AMENDMENTS TO THE DRAWINGS:

REPLACEMENT SHEET

FIG.6

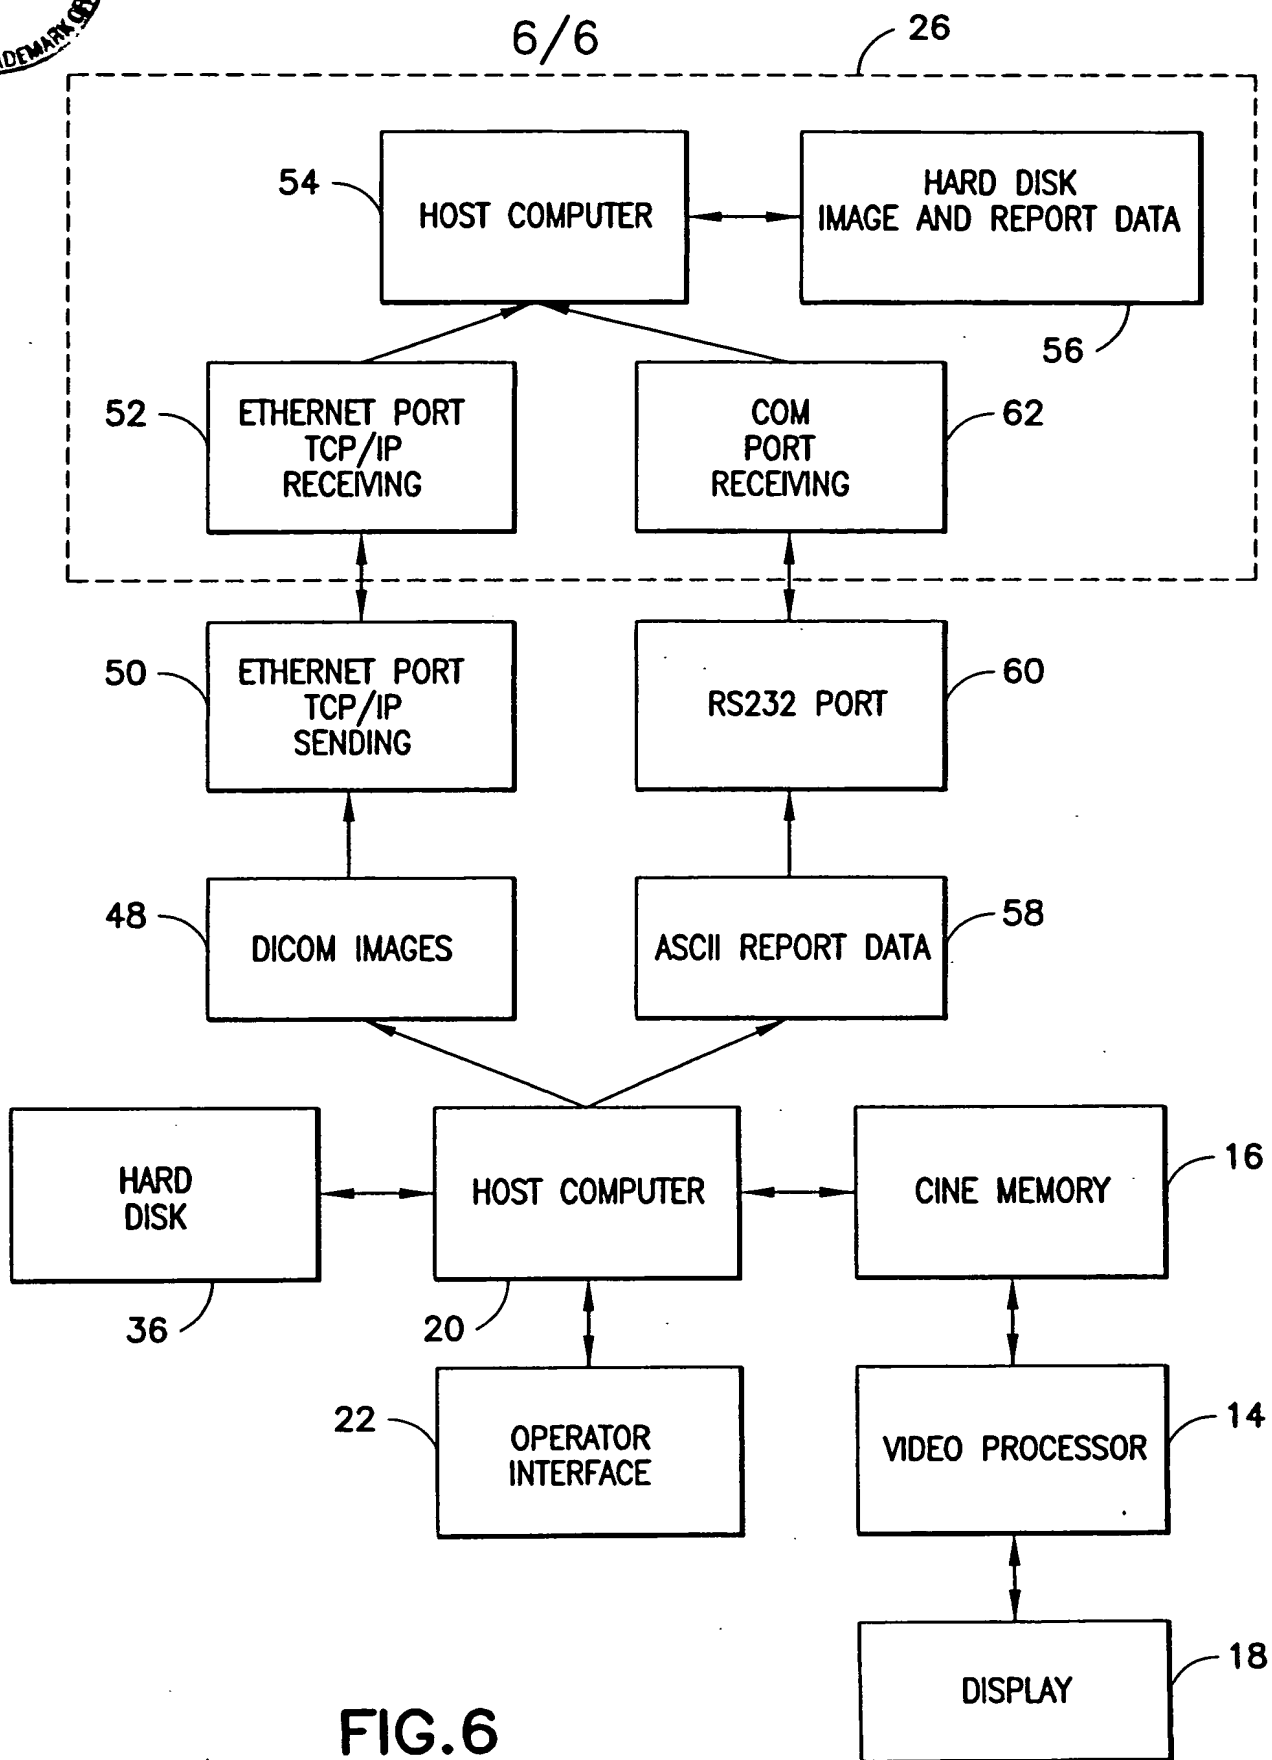
The Applicant proposes to amend the drawings as shown in the annexed copy of FIG. 6 labeled "ANNOTATED MARKED-UP DRAWING". The only change is the addition of an arrow going from block 48 to block 50, which arrow was apparently inadvertently omitted from the drawings as originally filed. Support for this change can be found on page 14 at lines 31-33, which states: "In accordance with the preferred embodiment of the invention, DICOM images 48 comprising an image header with a Study Instance UID are constructed by the host computer 20, transmitted from the Ethernet port 50, received by the Ethernet port 52, and stored on the hard disk 56 by the host computer 54." The addition of the arrow in FIG. 6 merely denotes the sending of the constructed DICOM objects 48 to the Ethernet port 50.

A new formal drawing bearing the designation "REPLACEMENT SHEET" and incorporating the aforementioned proposed amendment is also being submitted herewith.
